DOCKET 50-255 - LICENSE DPR-20 -
PALISADES PLANT - OVERPRESSURE
PROTECTION SYSTEM

CONSUMERS POWER COMPANY
Docket 50-255
Request for Change to the Technical Specifications
License DPR-20

PALISADES PLANT
PRIMARY COOLANT SYSTEM
OVERPRESSURIZATION SUBSYSTEM DESCRIPTION

FIGURE 2

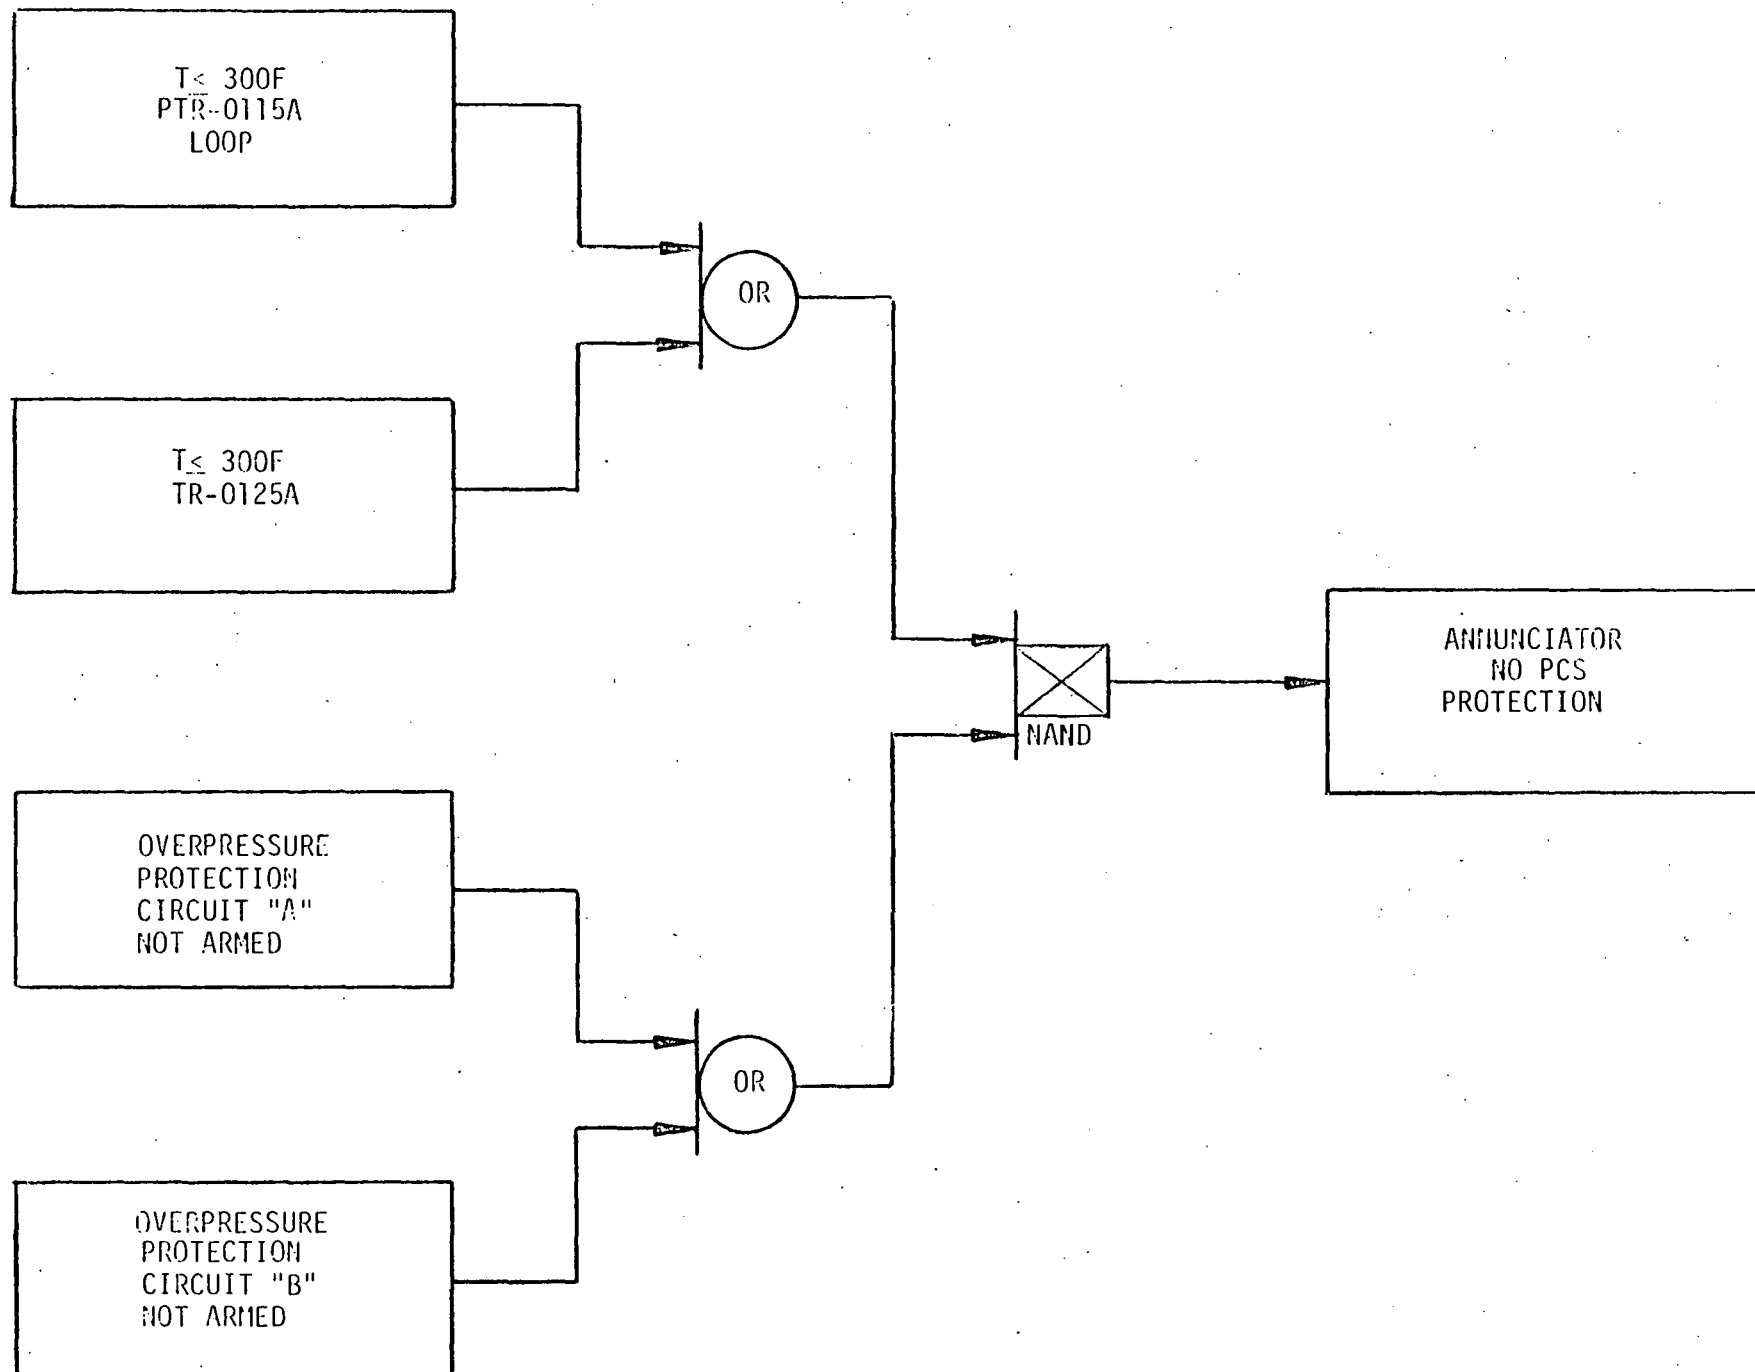
Staff Position: The position of the upstream isolation valve should be wired into the overpressure protection alarm so that the alarm will not clear unless the system is enabled and the isolation valve is open.

The overpressure protection system is designed to ensure that the isolation valves MO-1042A and MO-1043A must be open to allow the arming of the system. If, in fact, they are not opened, the "armed" indicating light will not illuminate when the keylock switch is turned to the "on" position and the annunciator window "no PCS protection" will alarm when the PCS temperature decreases below 300°F.

FIGURE 4b

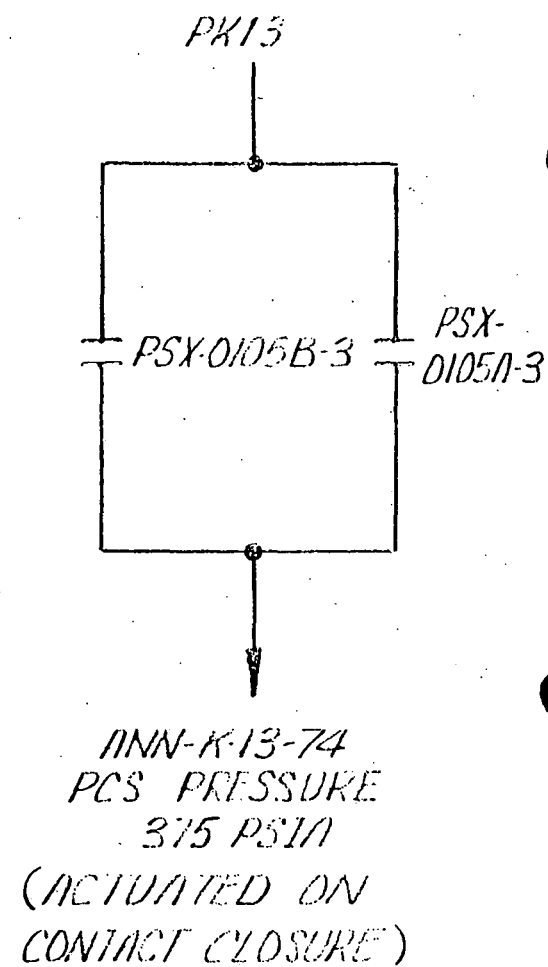
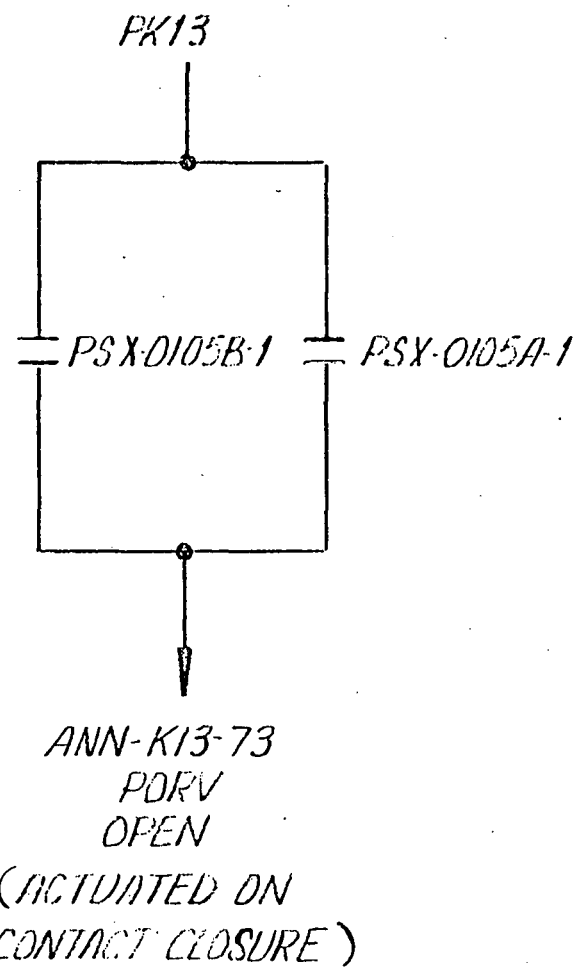
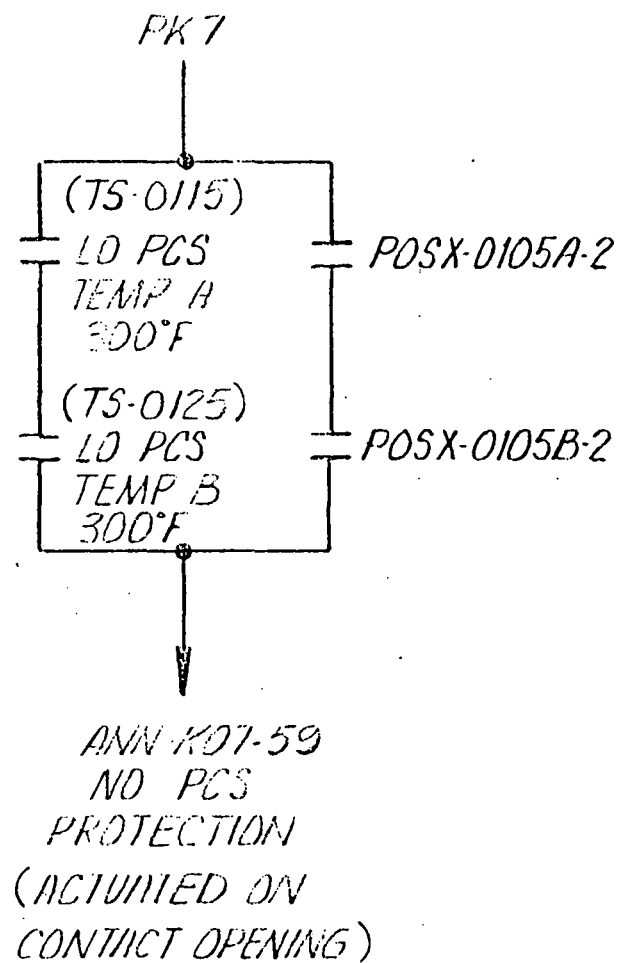
Staff Position: Licensees should submit a detailed diagram of the overpressure protection circuitry with their plant specific reports for review by NRC.

Detailed diagrams, schematics, and system operating description are included in the report "Palisades Plant Primary Coolant System Overpressurization Subsystem Description" and the construction package. This information is an attachment to this letter.
